Peer review of Arcadia Flood Study

Customer
Project
Deliverable
Version

Townsville City Council
A10416
006
00
03 May 2022

Figure 3.1 Subareas modelled with no impermeable area

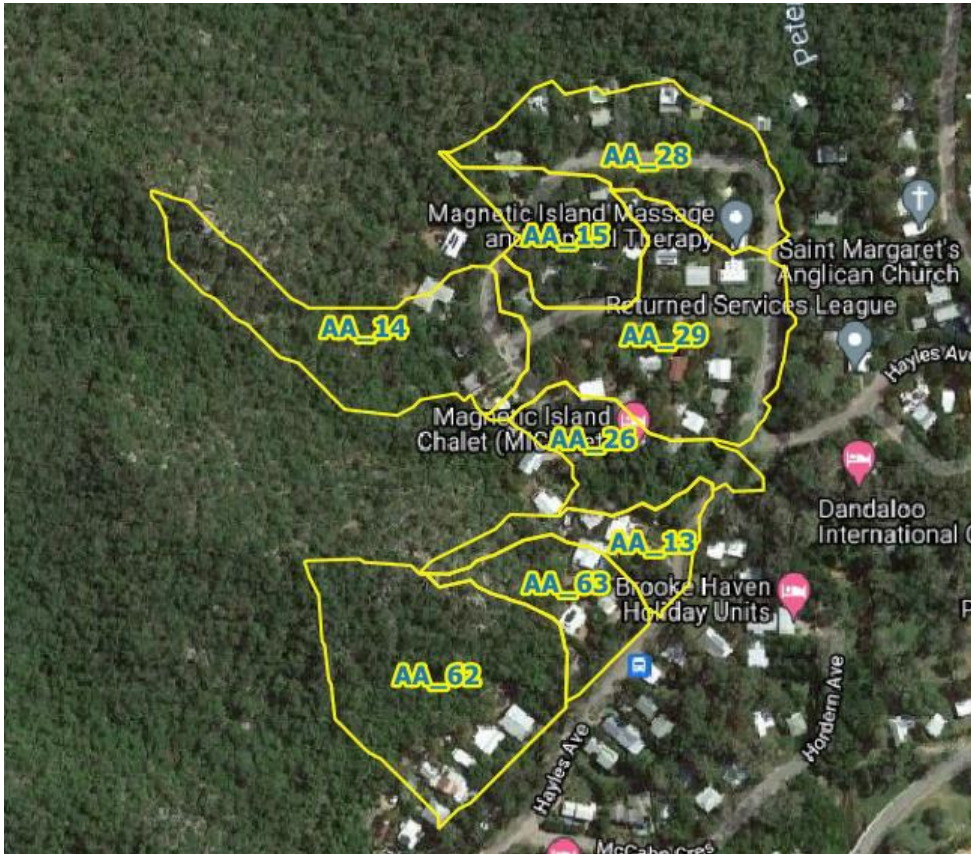
Impervious areas have been added to subareas AA1 to AA10. However, the developed area extends well beyond this selection of subareas. It is acknowledged that much of the runoff in the developed area is simulated using direct rainfall in the hydraulic model. However, there are still several subareas that span across developed areas where impervious areas have not been applied and direct rainfall is not used; a selection of these subareas is shown in Figure 3.1 below. This will result in an understatement of runoff from these subareas, albeit the differences are unlikely to be significant.

3.2	Some subareas were identified outside of the direct rainfall extent which contain impermeable land uses not represented in the model	Observation only. Affected areas are minor so it is not considered warranted to update them.
